**STATE OF NORTH DAKOTA
PUBLIC SERVICE COMMISSION**

**Courtenay Wind Farm, LLC
200.5 MW Wind Energy Center – Stutsman County
Siting Application**

Case No. PU-13-64

**NOTICE OF INTENT TO CONSIDER ADDITIONAL INFORMATION NOT
PRESENTED AT A HEARING**

Residence and Runway Location

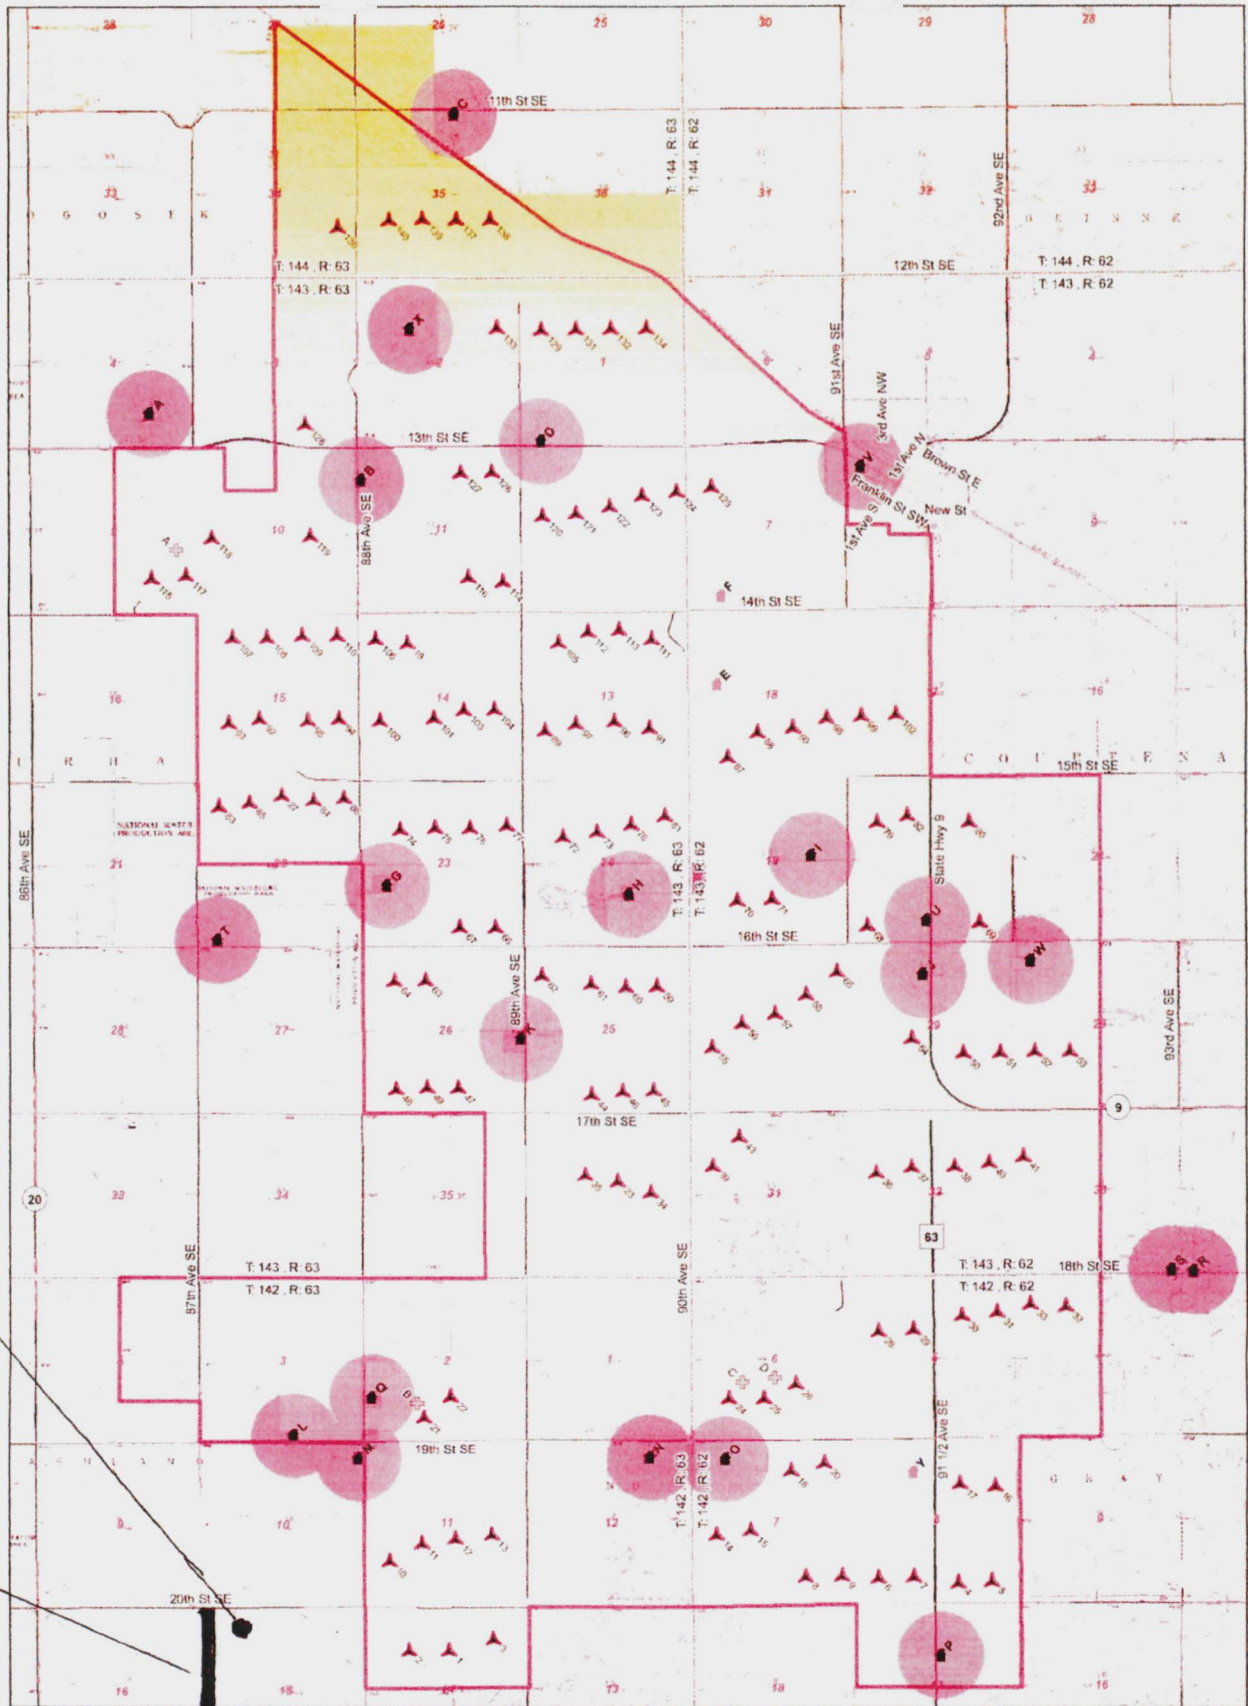
Concern # 1: Exhibit 4 Part B, clearly states that it includes homes within 5,000 ft of the project area. Exhibit 4 Part A shows locations of the residences. **Our residence is not listed on either exhibit 4 part B or shown on exhibit 4 part A.**

Our residence is within 5,000 ft of the project area. Our private runway (8ND7) is 5,230 ft from the project area.

We have attached a copy of Exhibit 4 Part A and marked our residence and runway

location. We have titled it residence and runway location.

We have concerns that turbines 1,2,3,10,11, 12,13,21,22, and permanent Met Tower B will affect the daily operations and safety of landings and take offs of our aerial spraying business runway. All the turbines are within two miles of the runway.

In conclusion, we are not against Courtenay Wind Farm and Geronimo Energy, but **we do ask that turbines 1,2,3,10,11,12,13,21,22, and permanent Met Tower B be moved elsewhere.** We hope this project does not get railroaded through before area residences receive accurate information from Geronimo Energy, on paper, as to where the turbines, and met towers will be located and have a chance to express their concerns.

Residence and Runway Location

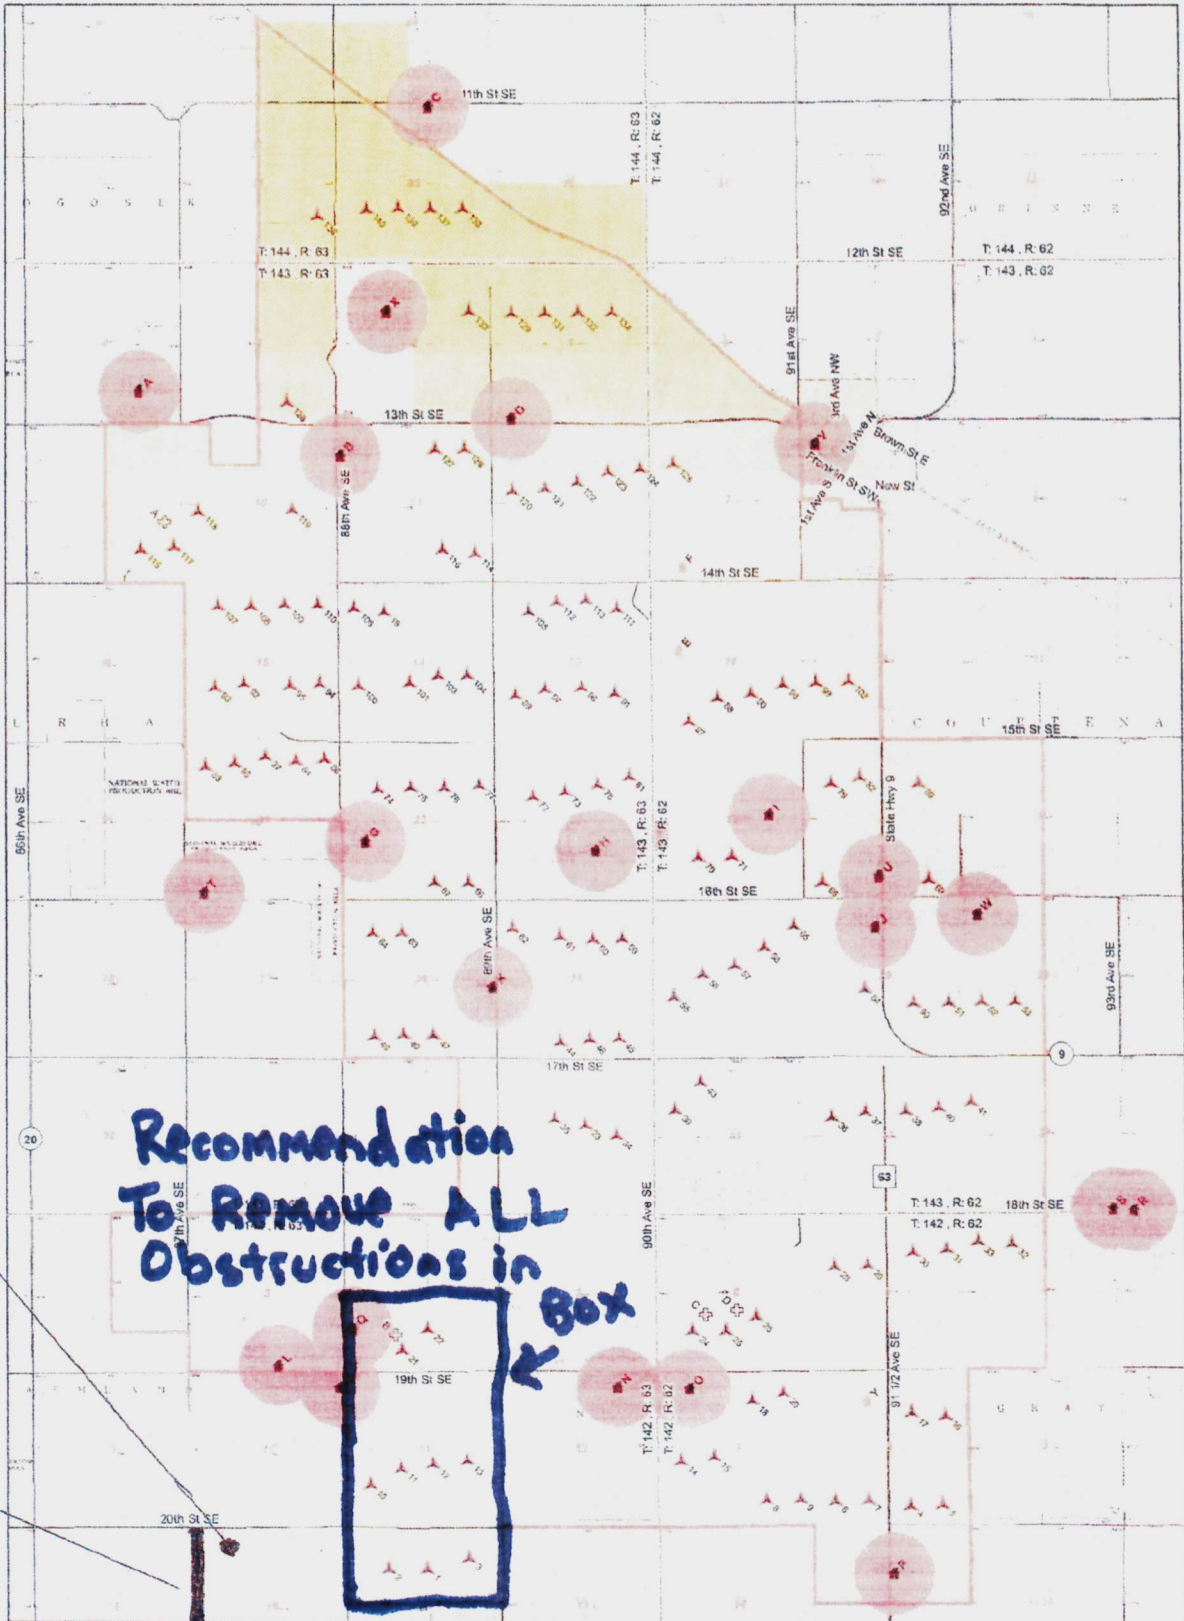
- An object constitutes an obstruction to navigation if the object is 200 ft. above the airport elevation when the obstruction is within 3 miles of an airport. With multiple wind turbines planned to be approximately 500 ft. above the airport elevation, this is a safety concern.
- The proposed wind turbines would also conflict with the FAA Part 77 conical airspace of the airport. This airspace is important for an airport, as it allows the safe transition of aircraft departing and arriving to the airport. (see attached illustration)
- The Sprague Airport is a registered and identifiable airport on the North Dakota sectional chart. The airport may be used by the public who are flying in the area and have an emergency. It is very important to protect any airspace that may be utilized by the public.

With the above listed concerns, it is recommended that the following wind turbines and permanent met towers be removed from the current proposal (see attachment):

- Permanent Met Tower B
- Wind Turbine 1, 2, 3, 10, 11, 12, 13, 21, 22

Recommendation
To Remove ALL
Obstructions in
Box
